Contract #: 04-0120F4Cty: SF/ALA Rte: 80 PM: 13.2/13.9File #: 69.25B**QUALITY ASSURANCE -- NON-CONFORMANCE REPORT****Location:** Changxing Island, Shanghai, P.R. China**Report No:** NCR-000715**Prime Contractor:** American Bridge/Fluor Enterprises, a JV**Date:** 23-Apr-2010**Submitting Contractor:** Zhenhua Port Machinery Company, Ltd (ZPMC), Changxing Island**NCR #:** ZPMC-0682**Type of problem:**

Reference Description: Fabrication of Segment 9DE Floorbeam cope holes not according to the approved shop drawings

Subject: NCR No. ZPMC-0682

Document No.: ABF-NPR-000651 Rev: 00

Description of Non-Conformance:

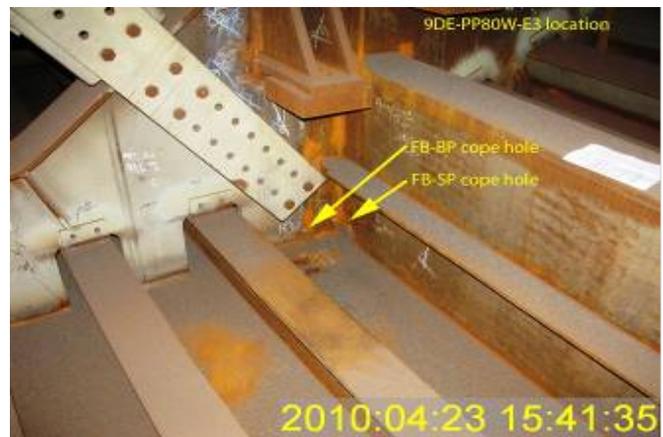
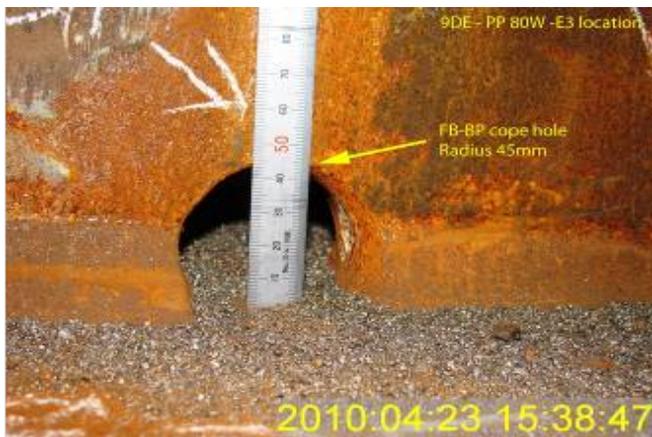
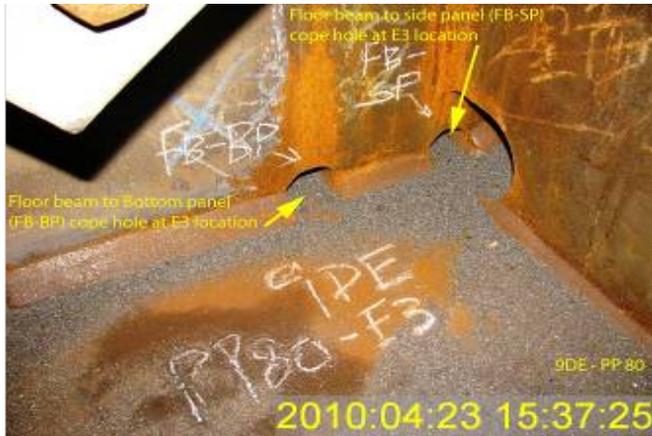
During in-process inspection of Segment 9DE, Caltrans Quality Assurance Inspector found the following issues while measuring the size of the cope holes:

-Some cope holes at the below floorbeam locations are found to be oversized, not fabricated according to approved shop drawings which indicate a radius of 25mm.

- Panel Point (PP) 80, Working Point E3, Floorbeam (FB) to Bottom Panel (BP) cope, 45mm radius
- PP80, Working Point E3, FB to Side Panel (SP) cope, 40mm radius
- PP80, Working Point E4, FB to BP cope, 45mm radius
- PP81, Working Point E3, FB to BP cope, 44mm radius
- PP81, Working Point E3, FB to SP cope, 43mm radius
- PP81, Working Point E4, FB to BP cope, 40mm radius
- PP82, Working Point E3, FB to BP cope, 44mm radius
- PP82, Working Point E3, FB to SP cope, 44mm radius
- PP82, Working Point E4, FB to BP cope, 45mm radius

ABF performs dimensional inspections of cope holes. These cope hole inspections are forwarded to CT for review. The cope holes listed on the NCR are slightly oversize, however, ZPMC/ABF prefer to leave these cope holes as is. Further repair by welding to reduce the size of cope holes will undoubtedly cause significant problems with weld quality in these difficult to access areas. The root cause of the oversize holes is over grinding by production personnel not completely understanding the tolerance issues involved. Production personnel were trying to achieve a visually acceptable weld terminations within the cope holes and smooth transitions, which, as shown by the photos, is well within acceptable limits. ABF has met with ZPMC to discuss ways to prevent over grinding of cope holes so as to prevent future occurrences of these types of nonconformances.

This proposed resolution is acceptable. The Department concurs that Non-Conformance ZPMC-0682 is closed.

Cope holes were found to be acceptable as is.
